REMARKS

Application No. 10/089,247
Paper Dated: March 5, 2004
In Reply to USPTO Correspondence of November 7, 2003
Attorney Docket No. 1918-020512

"Cooking Apparatus"
Inventor: Kenneth Michael Hall
Application No. 10/089,247
Annotated Sheet Showing Changes

FIG 8

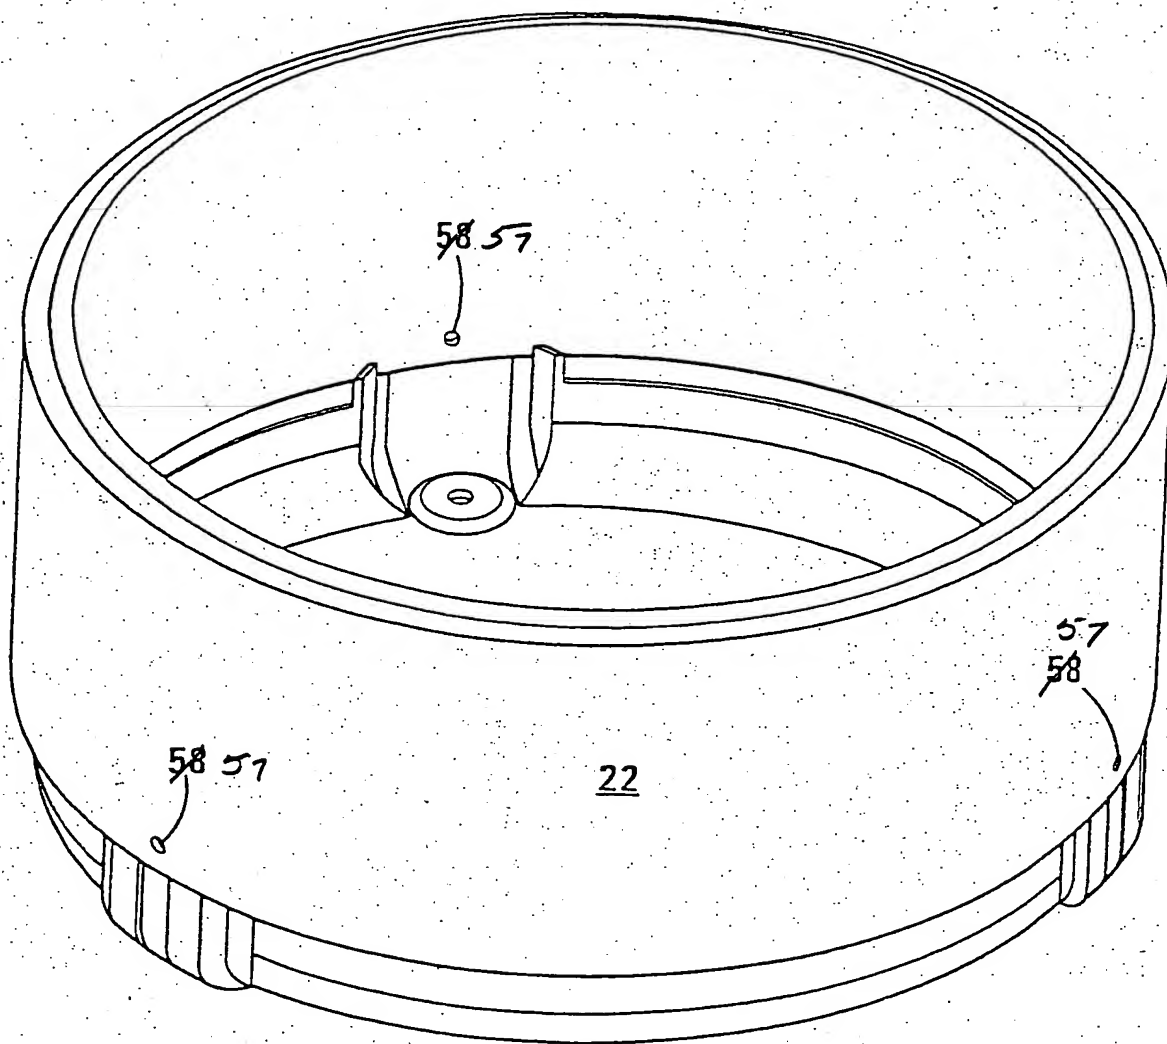
The drawings stand objected to for not including cross hatching for "insulation 34" identified in Fig. 1, and for duplicate use of reference numeral "58". Applicant includes herewith proposed drawing changes to Figs. 1, 8, and 9 for the Examiner's review and approval. The appropriate cross hatching has been added to Fig. 1 and reference numeral "57" has been included in Figs. 1, 8, and 9 to represent "aperture(s)", as set forth in the last paragraph on page 7 of the specification.

The specification also stands objected to for duplicate use of reference numeral "58". Applicant has amended the last paragraph on page 7 of the specification to include reference numeral "57" in place of reference numeral "58". In view of the foregoing changes to the specification and the proposed drawing changes included herewith, Applicant respectfully requests reconsideration of the Examiner's drawing objections and objections to the specification. Replacement drawings for all of Figs. 1-9 also accompany this Amendment, and include the changes indicated previously to Figs. 1, 8 and 9.
